REVISION #	DATE	ISSUE PURPOSE
2	5/24/20	AS - 01 Revision for HANO Review

**2256 BARONNE ST.**  
 2256 Baronne St. New Orleans, LA 70113

HANO REVIEW

## PHILIP STREET AND BARONNE ST. VIEW

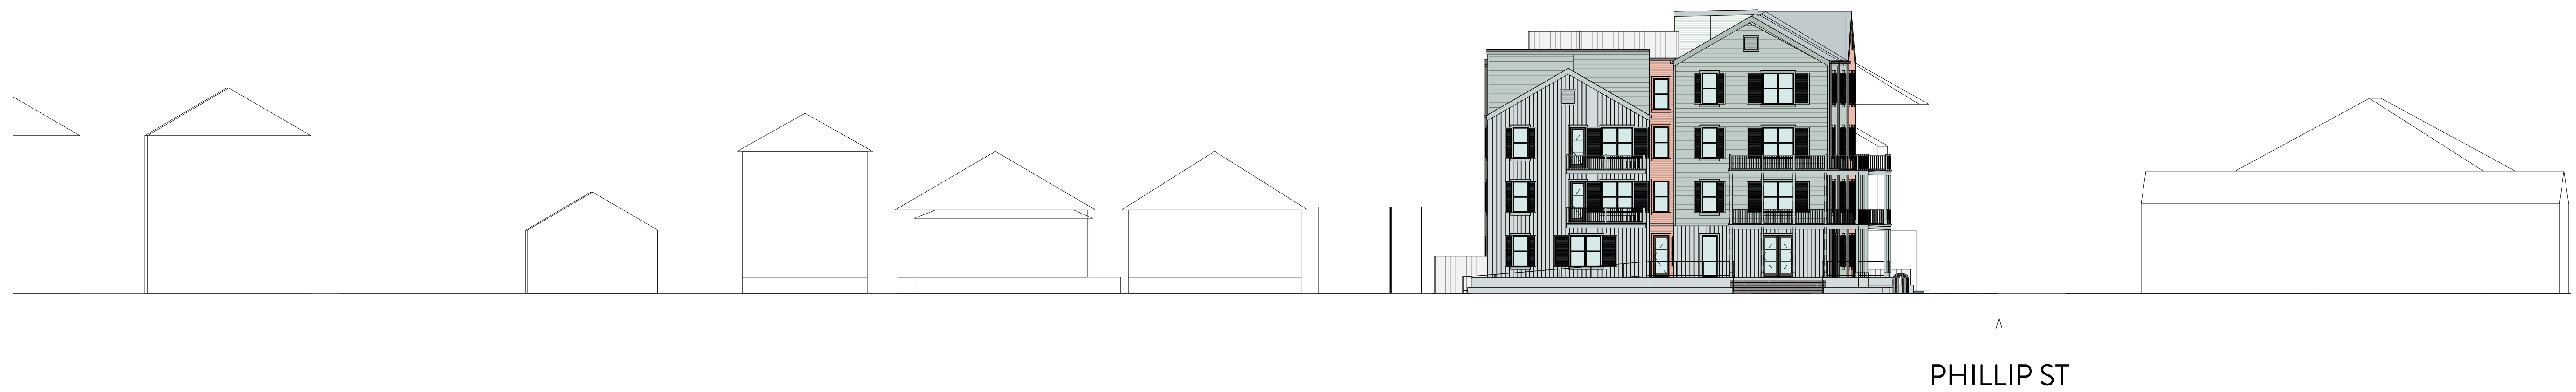
- Two-story, wrap-around gallery added to the Baronne/Philip corner. This introduces the form, proportion, detailing, and location of a traditional New Orleans gallery to the project's most prominent corner. It provides extensive cover for the porch outside the Community Room, a shady space for building residents to sit and be a part of the street life in their neighborhood and offers the residential units above a wonderful amenity.

- A guardrail has been added to the Community Room porch for resident safety. It will match the stair handrails in design.
- Two-story gallery added to the end of the building closest to the parking lot on the Philip Street side. Another prominent location, a gallery here reinforces the street presence of the building and ties it back to the more historic structures around the new building. It provides a covered entry to the first floor unit (whose front door has been relocated so it faces Philip Street), and amenities to the units above.

- Cantilevered balconies have been added to units facing Baronne Street and the parking lot. Introducing exterior space on upper floors that speaks back to New Orleans porches. These balconies are intentionally simpler in form to ensure the galleries maintain their sense of prominence on the facades.

- On the Jackson Avenue side of the building, Juliette balconies have been introduced to upper units. These break up the façade on that side, as well as offering the residents an amenity. (Projecting balconies aren't possible due to the setback requirement.)

- A combination of fiber cement lap siding has been further refined to introduce greater differences in the scale of those materials: 10", 6" and 2" lap siding exposures help the building masses to be read as individual pieces, visually breaking down the building into a composite of parts, rather than a single mass.
- Exterior cladding colors shown are indicative of an intent to distinguish the building masses from each other, and the final color selection will be determined in the Construction Phase.

- Windows have been re-sized from 3' x 5' to 3' x 6', more closely referencing the proportions of historic New Orleans windows. This subtle change brings the building into closer relation to its neighbors.
- Window trim has been increased in size to more closely reflect traditional New Orleans window trim.
